Docket No. 50-320

To complete the review of your application with regard to compliance with 10 CFR 50.46, certain material is needed which may be in addition to that submitted in the B&W topical reports covering the ECCS systems.

Attachment 1:
Required Information

Attachment 1
REQUIRED INFORMATION

Figure 1
Area of Steel Heat Sinks Inside Containment

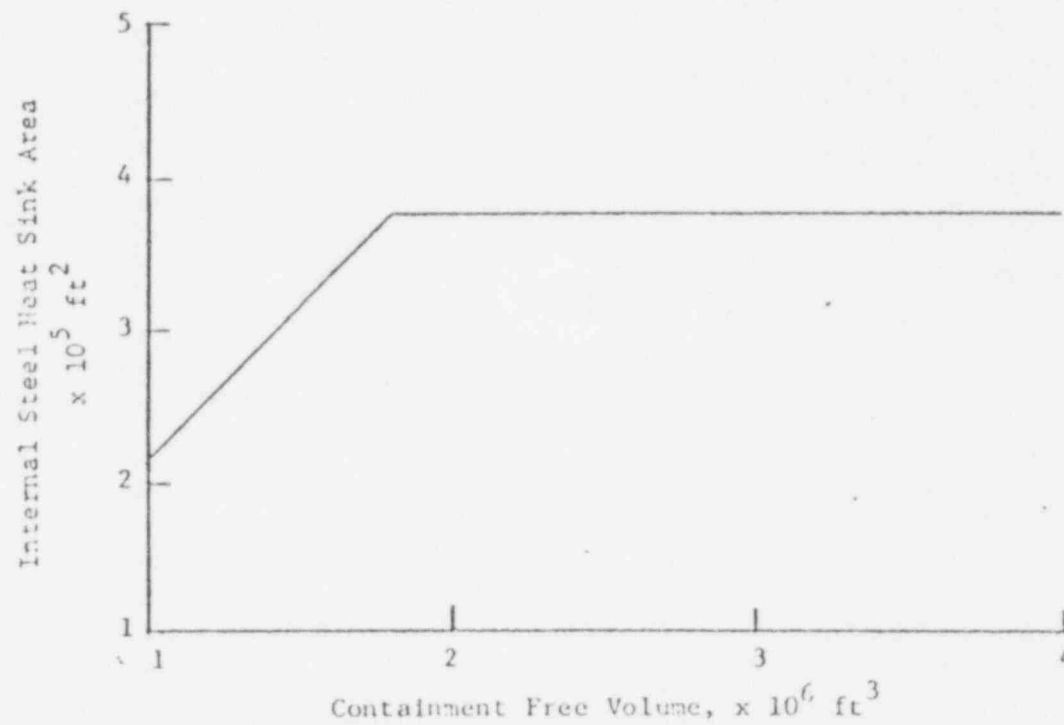
- (1) Use the surface area and thickness of the primary containment steel shell or steel liner and associated anchors and concrete, as appropriate.
- (2) Estimate the exposed surface area of other steel heat sinks in accordance with Figure 1 and assume an average thickness of 3/8 inch.
- (3) Model the internal concrete structures as a slab with a thickness of 1 foot and exposed surface of 160,000 ft².

Figure 2
Condensing Heat Transfer Coefficients for Static Heat Sinks

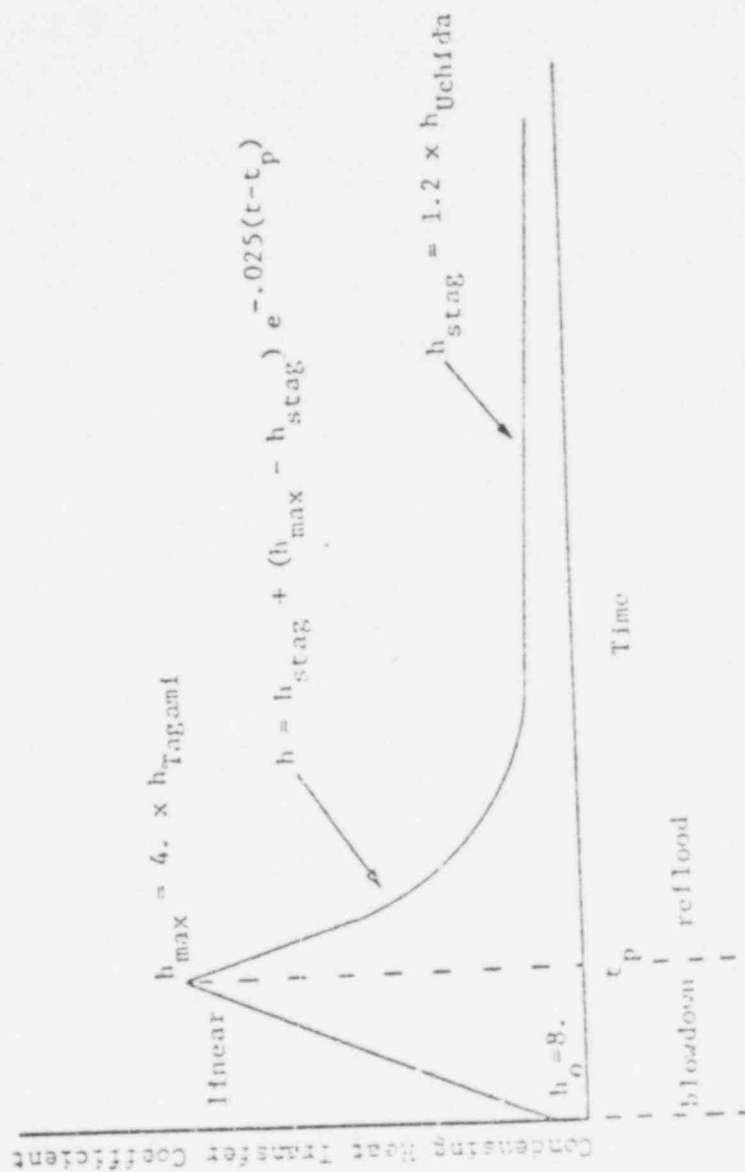
The following conservative condensing heat transfer coefficients for heat transfer to the exposed passive heat sinks during the blowdown and post-blowdown phases of the loss-of-coolant accident should be used (See Figure 2):

- (1) During the blowdown phase, assume a linear increase in the condensing heat transfer coefficient from $h_{\text{initial}} = 8 \text{ Btu/hr-ft}^2\text{-}^\circ\text{F}$, at $t = 0$, to a peak value four times greater than the maximum calculated condensing heat transfer coefficient at the end of blowdown, using the Tagami correlation

- (3) During the transition phase of the accident, between the end of blowdown and the long-term post-blowdown phase, a reasonably conservative estimated transition in the condensing heat transfer coefficient should be assumed (see Figure 2).
